STAFF REPORT: 4/12/2023 REGULAR MEETING

APPLICATION NUMBER: #23-8288

ADDRESS: 1600, 1883 WOODWARD AVE

SCOPE: ESTABLISH MASTER PLAN

Figure 2 by Applicant: Master Plan, showing proposed concept with existing features overlaid (dark outlines).

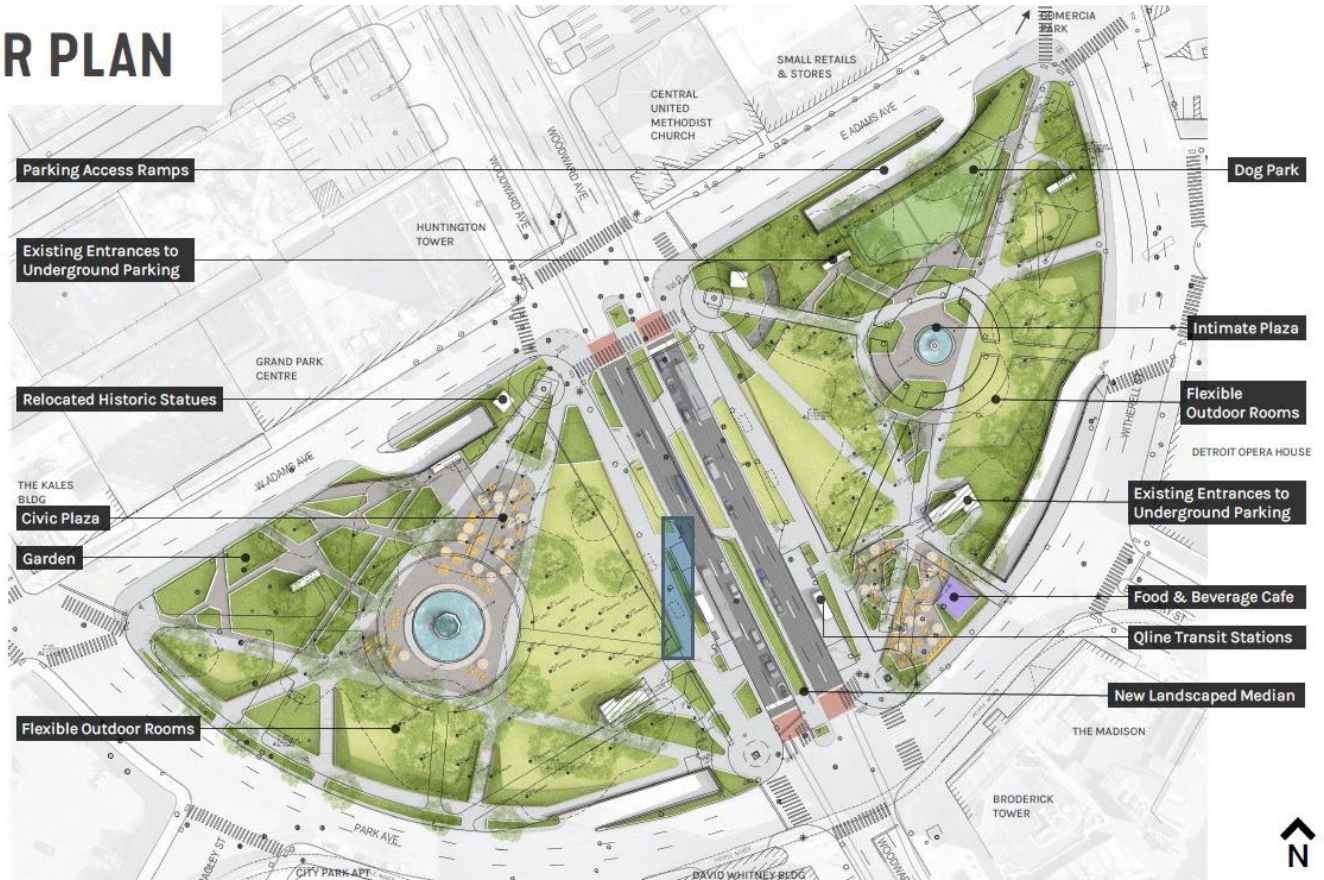
- Regarding the proposed new building, note that its permanence will take away some of the flexible use space of the park. However, it is staff's opinion that the erection of a new building in the park as depicted in the Master Plan is appropriate because it is at a location and scale that largely retains the open space of the park. However, note that Chapter 21 requires the Commission to hold a public hearing for new construction within local historic districts. Staff does not recommend that the Commission grant us the authority to approve the new café at this time as the Master Plan does not provide documentation for public review/scrutiny beyond a footprint to indicate a general location, and a white box rendering to note general form and scale. It is staff's opinion that the DDP should present an application for the cafe to the Commission for review at a regular meeting once they have detailed documentation of the building, that being a schematic design level at a minimum. The proposal would then be subject to public hearing in front of this body.

- The proposed garden in the west park's northwest corner has several newly introduced pathways that impact the open green lawn. Staff recommends that the new pathways in this location be composed of a "lighter" material (such as crushed granite) versus the more permanent concrete pathways which the Master Plan proposes to install. Similarly, the planting beds/plantings in this area should be flexible in nature (ie., no masonry edging or retaining walls, etc.)

- Staff finds that the Master Plan's alterations of the existing, centrally located plazas are appropriate because they retain the key character defining features of each plaza: key axial views to the central focus point of the fountains and the use of flexible open space around the fountains as a feature of the hardscape.

- Staff has the opinion that the master plan retains the historic, distinctive character-defining features of the radiating pathways and their axial features.

- Staff has the opinion that the proposed plan to move the historic statues adjacent to their current locations and adding planting beds around them is appropriate.

It is staff's opinion that the project generally conforms to the Elements of Design for the district and meets the Secretary of the Interior's Standards for Rehabilitation. Staff therefore recommends that the Commission issue a Certificate of Appropriateness for the Master Plan as proposed with the following conditions:

- The applicant shall present an application for the cafe to the Commission for review and approval at a regular meeting once they have more detailed documentation of the building, prior to the issuance of the project's permit, and that review shall be subject to Public Hearing under Section 21-2-77.
- Staff shall have the authority to review and approve the final design of all aspects of the work outlined in the Master Plan document (outside of the proposed new building) prior to their implementation.
